RICHLAND TOWNSHIP

**Re: Proposed 15 x 20 Porch
Tax Map Parcel No. 36-28-62**

I have reviewed the submitted sketch plan identifying the existing dimensions of the improvements of the above referenced property and offer the following comments:

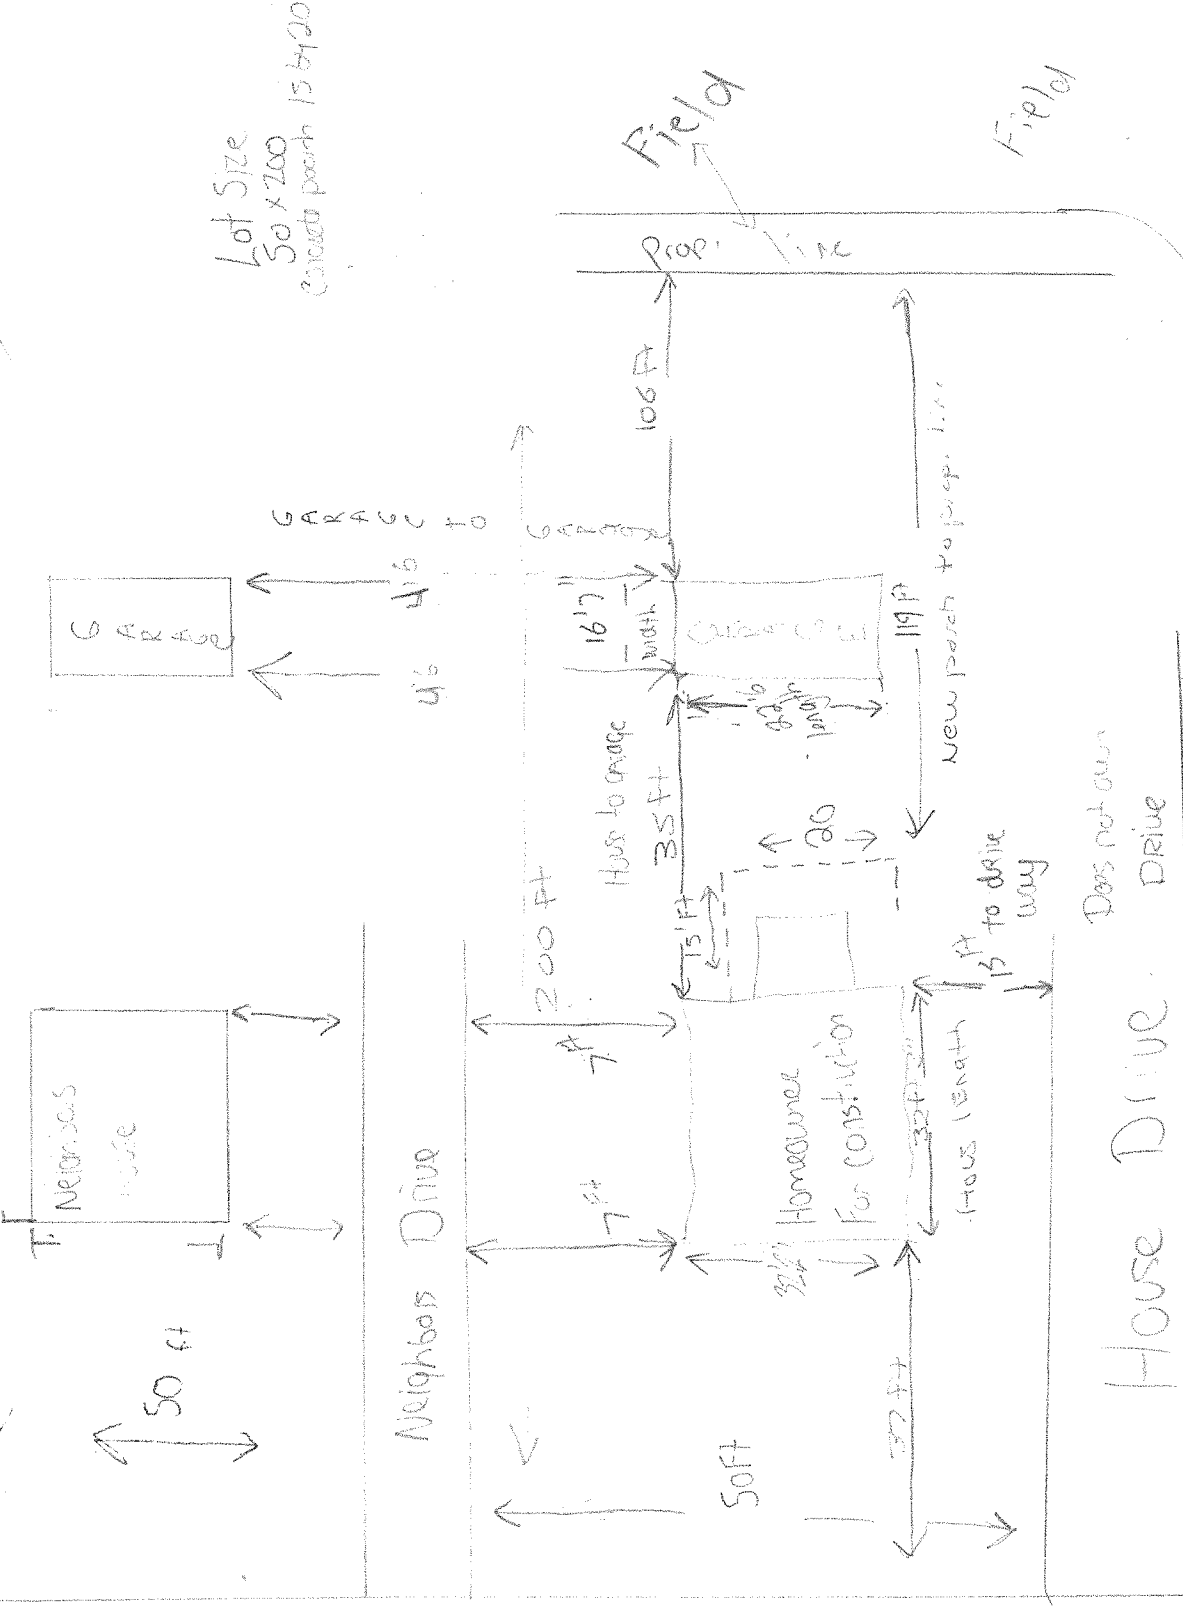
1. The property is located in the SRC Zoning District, and the use of the property is a B1 single family detached dwelling use.
2. The lot size as indicated is 50 x 200 10,000 sq ft. The maximum allowable building coverage is 10% percent and the maximum impervious surface allowable is 5% percent. It is noted, that the lot is nonconforming as it relates to the existing building and impervious coverages exceed both the maximum allowable building and impervious coverages, thus variances will be required.

If you would like to proceed with the submission of a Zoning Hearing Board application, please be advised, the sketch plan as submitted will not be sufficient for the hearing. You are required to have a plan completed by a Professional Engineer identifying the lot size, setbacks required for the zoning district, location of existing structures and improvements with the associated dimensions along with providing the site capacity calculations as defined in the Zoning Ordinance.
